SUBJECT: Indian Point Unit No. 2, Spent Fuel Pool Storage Capacity Increase
(TAC 72962)

References 1 and 2 contained figures which have recently been revised. Attachment I to this letter contains the revised figures and a description of the changes including the changes to References 1 and 2.

ATTACHMENT I

CONSOLIDATED EDISON COMPANY OF NEW YORK, INC.
INDIAN POINT UNIT NO. 2
DOCKET NO. 50-247
FEBRUARY, 1990

FIGURE 1

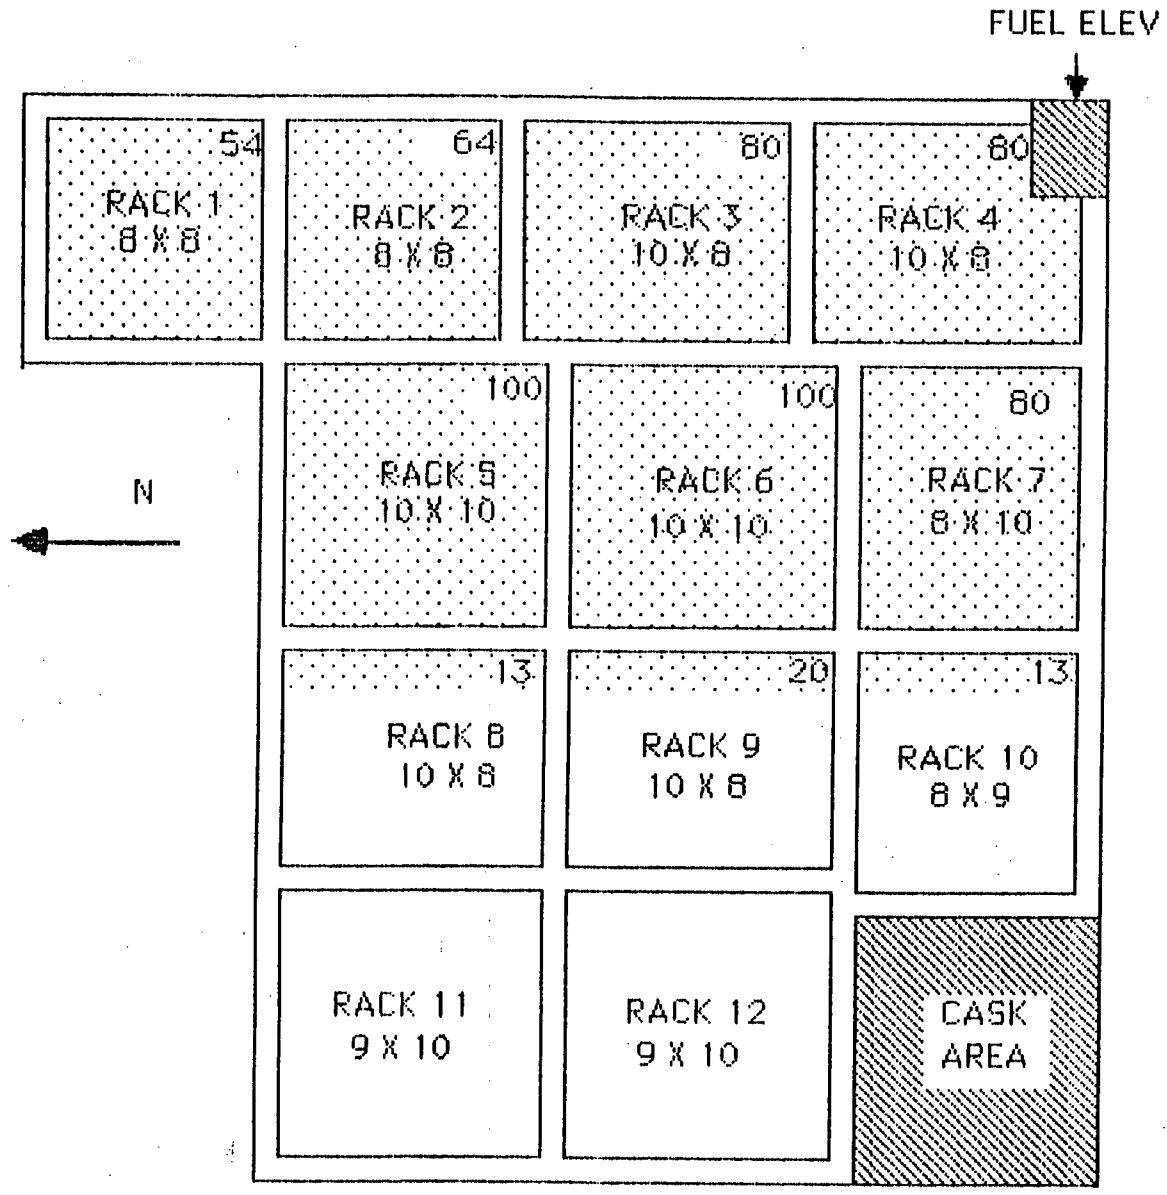
The rack installation and removal sequence and proposed fuel shuffle steps for the Indian Point 2 rerack have been revised as part of the current review and finalization of the installation procedures. These steps have been revised to facilitate a more efficient reracking process. The steps for the rerack were provided in Figures 1-6 in the response to question IV.2 in Reference 1 and the response to question 2 in Reference 2. Figures 1-8 hereto contains the revised steps and replaces Figures 1-6 as provided earlier. Figures 1-8 provide proposed fuel shuffles which meet the objective of maintaining a minimum distance of four feet between stored fuel and a rack being lifted when the rack is more than six inches above the pool floor or obstructions located on the pool floor. The dimension "x" in Figures 2-8 shows the distance between the stored fuel and a rack at those points where it is permissible for the rack to be more than six inches above the pool floor or an obstruction.

INSTALLATION AND REMOVAL
SEQUENCE AND PROPOSED FUEL
SHUFFLE STEPS:

Shuffle fuel assemblies
to obtain configuration
shown

FIGURE 2

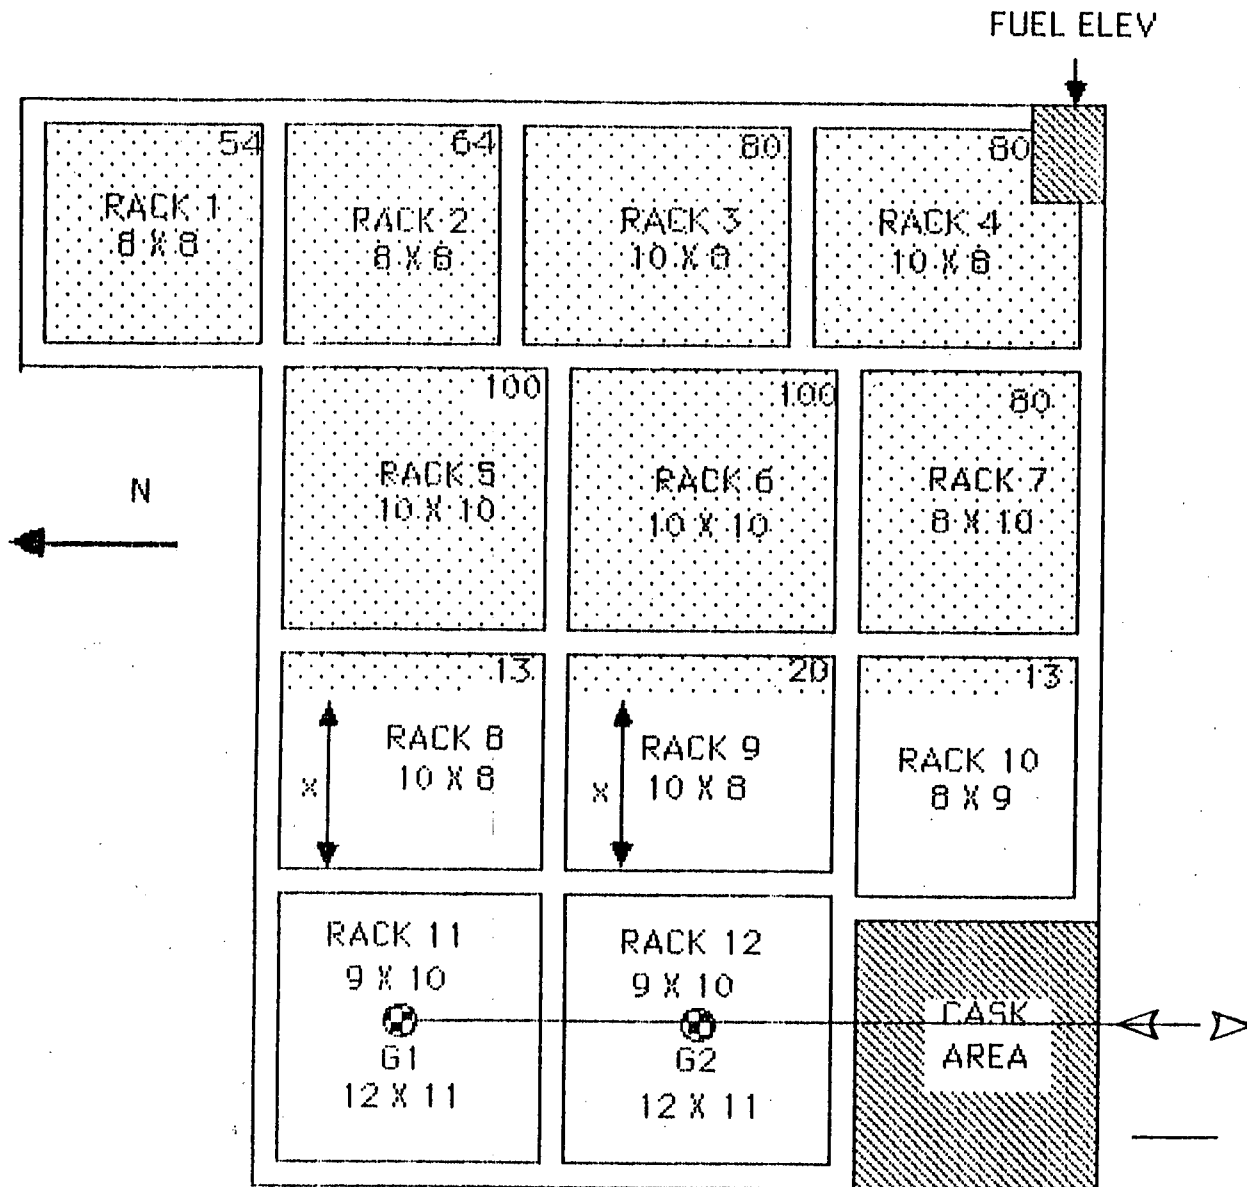
INSTALLATION AND REMOVAL
SEQUENCE AND PROPOSED FUEL
SHUFFLE STEPS:

Remove racks 11 and 12

Install racks G1 and G2

FIGURE 3

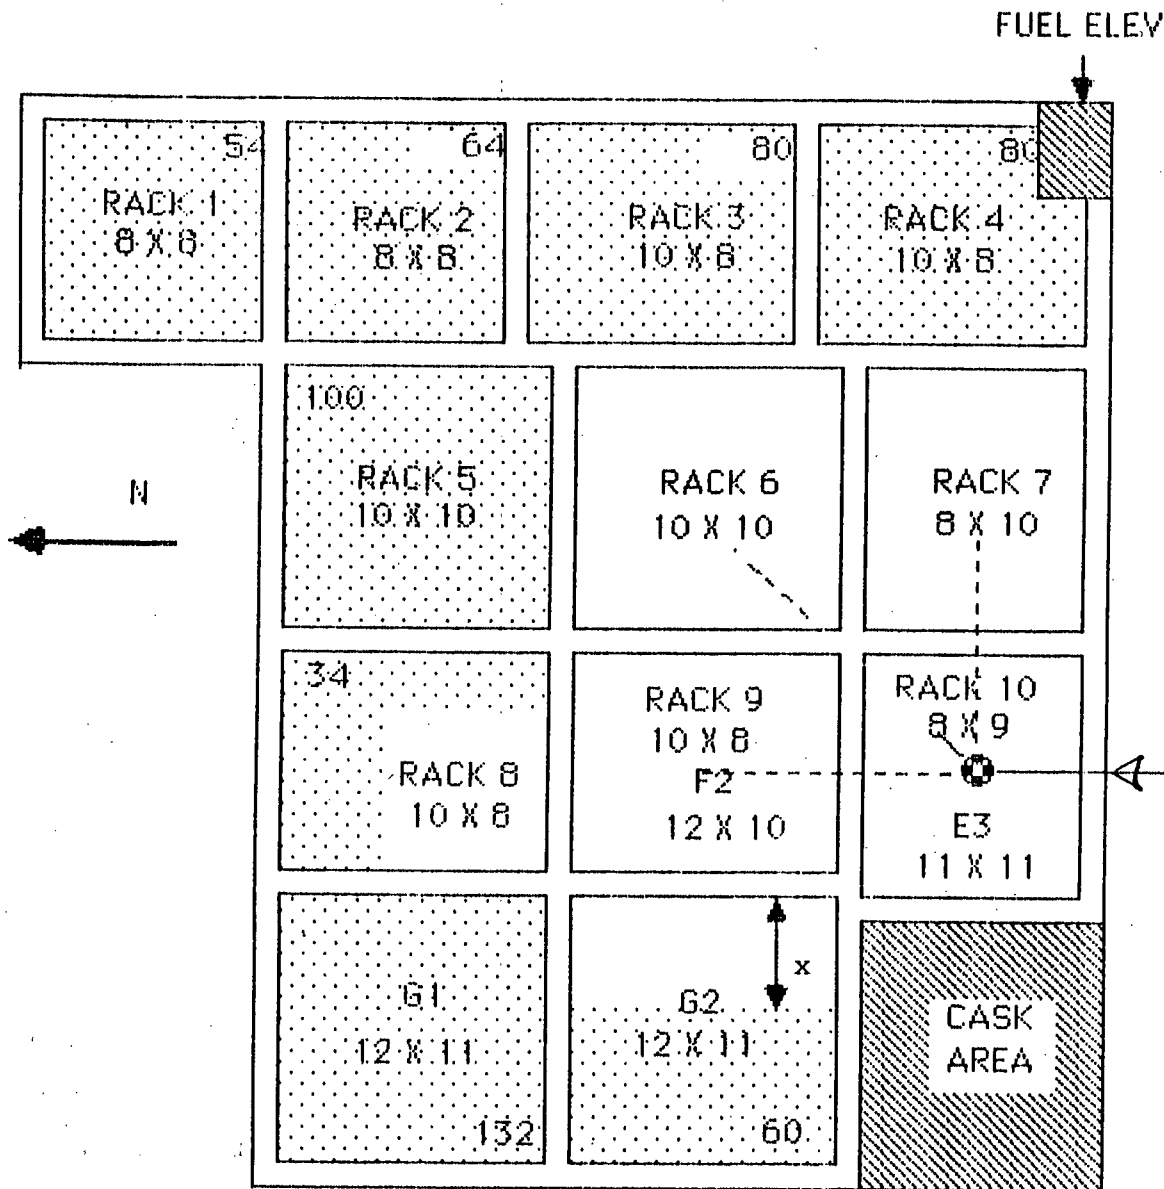
Shuffle fuel to obtain the configuration shown.

Remove racks 10, 7, 9, 6
Install racks F2 and E3

----- rack movement under water 6" above the pool floor or pool floor obstructions.

FIGURE 4

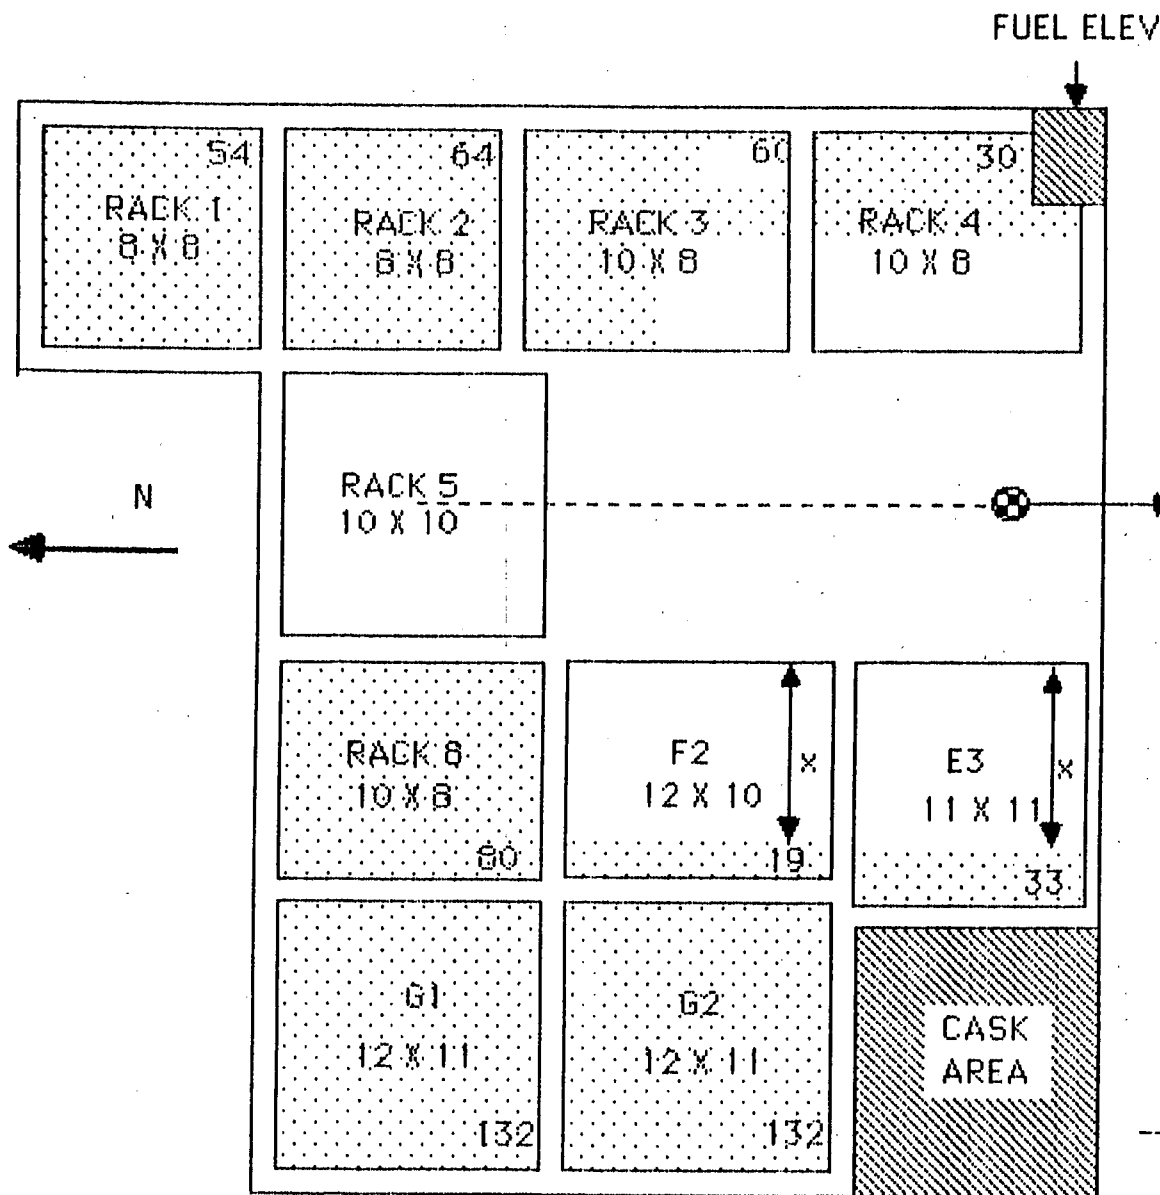
Shuffle fuel assemblies to obtain the configuration shown.

Remove rack 5
x > 4'

----- rack movement under water 6" above the pool floor or pool floor obstructions

FIGURE 5

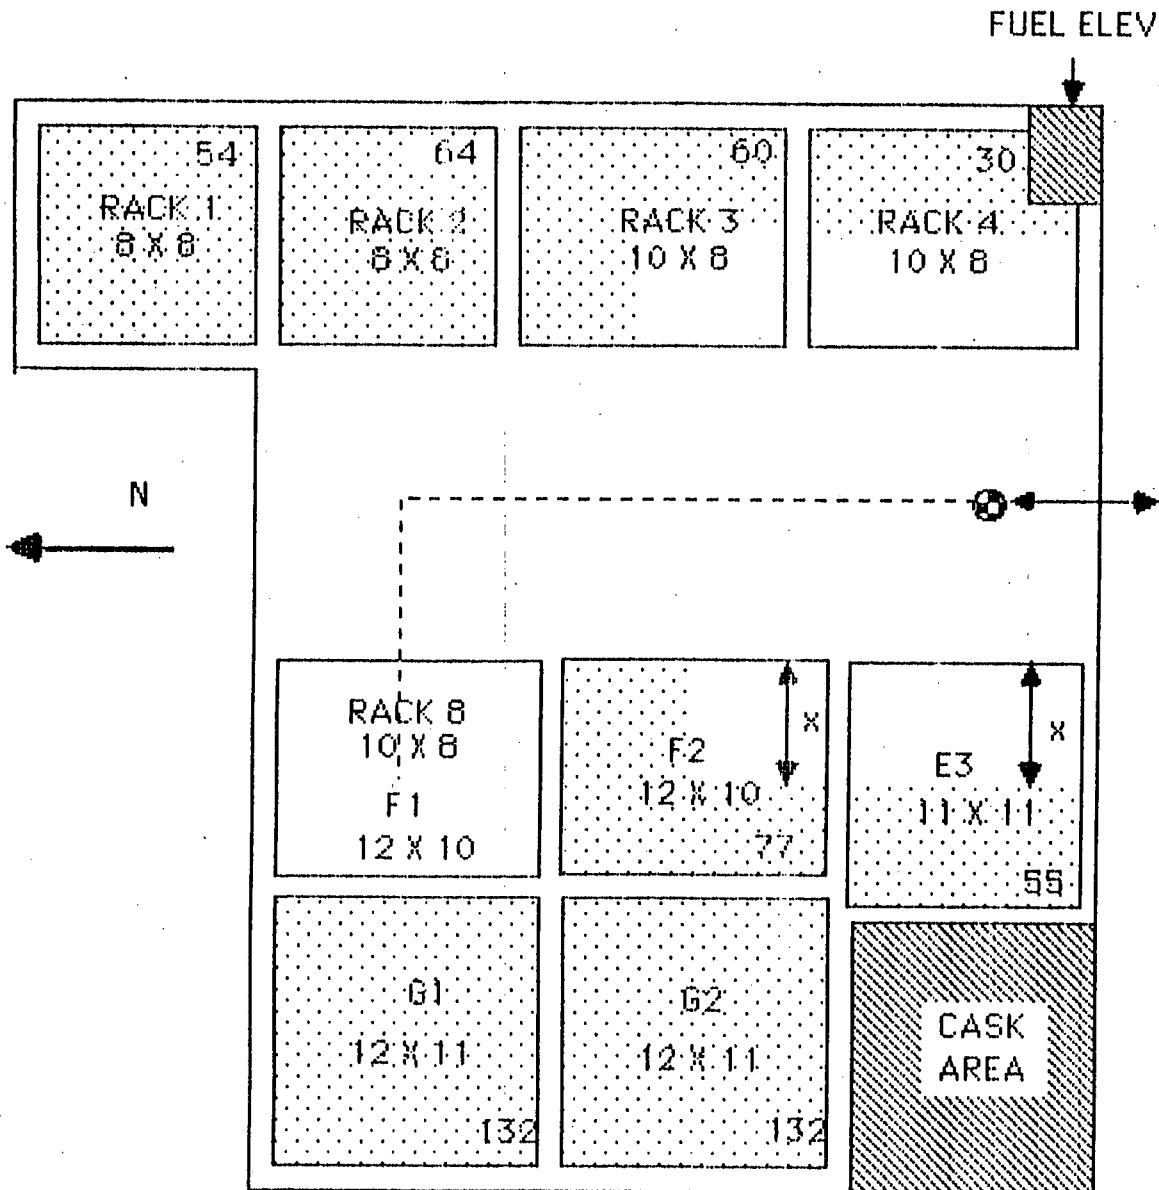
Shuffle fuel assemblies to obtain
the configuration shown.

Remove rack 8

Install rack F1

----- rack movement under water 6"
above pool floor or pool floor
obstructions

FIGURE 6
INDIAN POINT UNIT II
INSTALLATION AND REMOVAL
SEQUENCE AND PROPOSED FUEL
SHUFFLE STEPS:

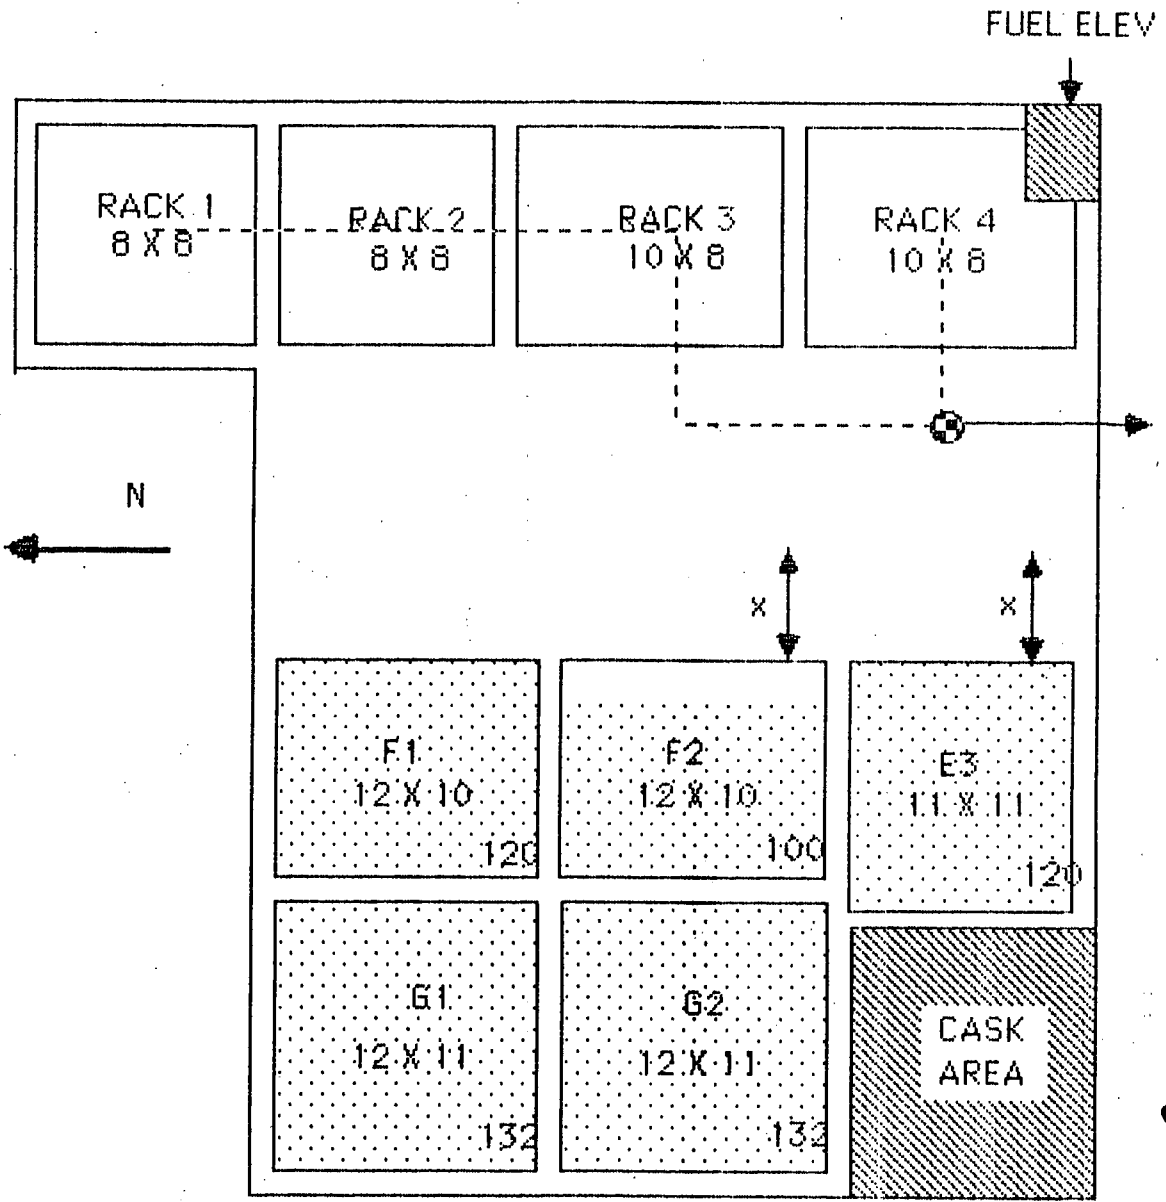
Shuffle fuel assemblies to obtain the configuration shown.

Remove racks 4, 3, 2, and 1

----- rack movement under water 6" above the pool floor or pool floor obstructions.

FIGURE 7

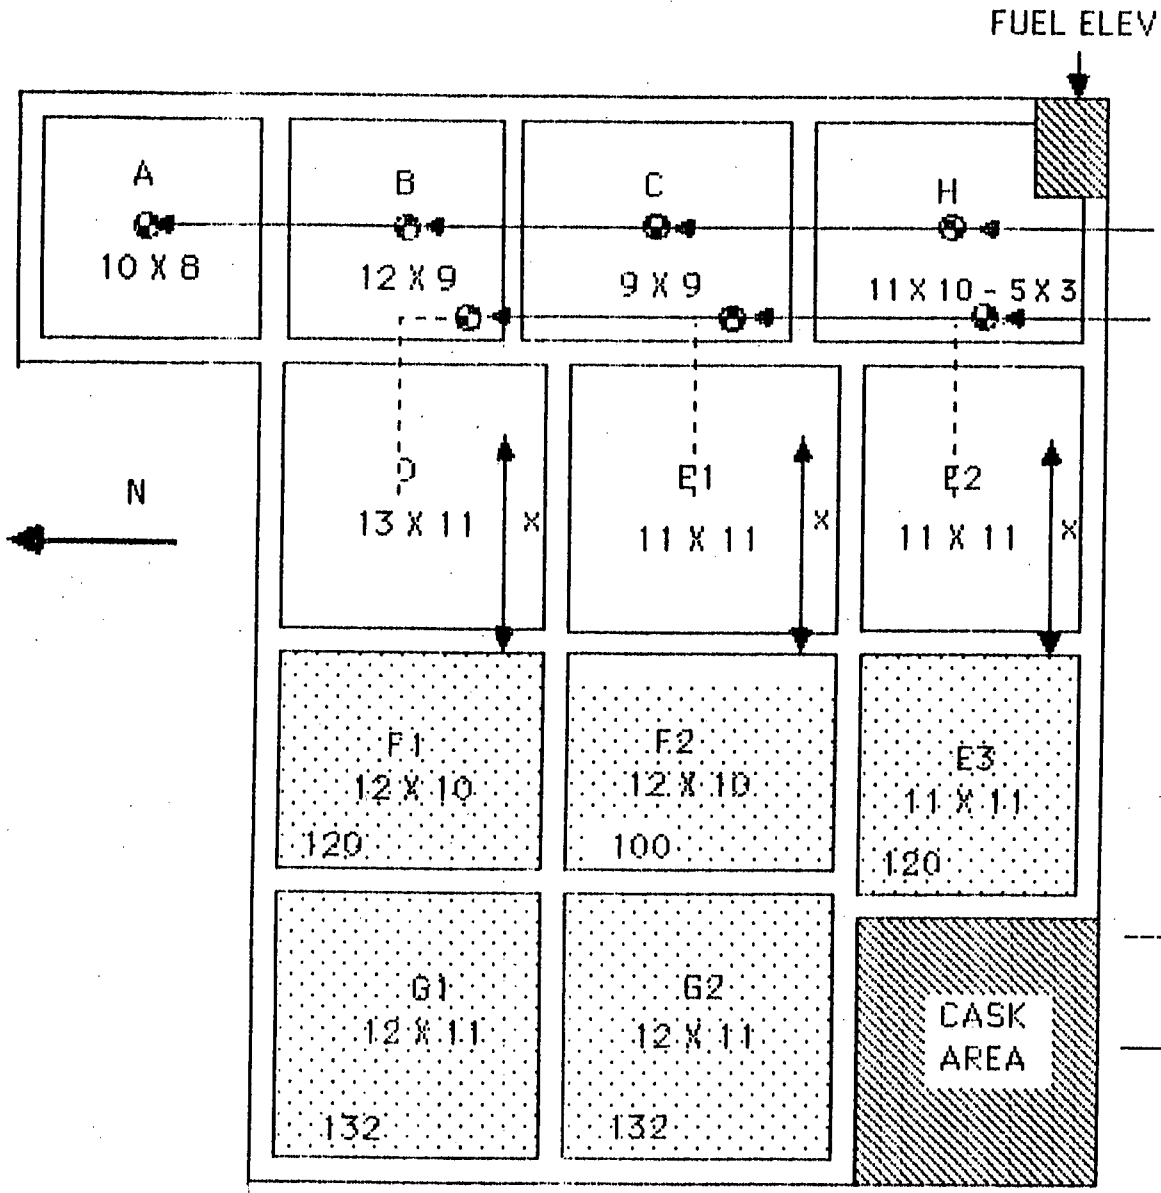
Install the remaining racks in the following sequence:

A, D, E1, E2, B, C, and H.

----- rack movement under water 6" above pool floor or pool floor obstruction
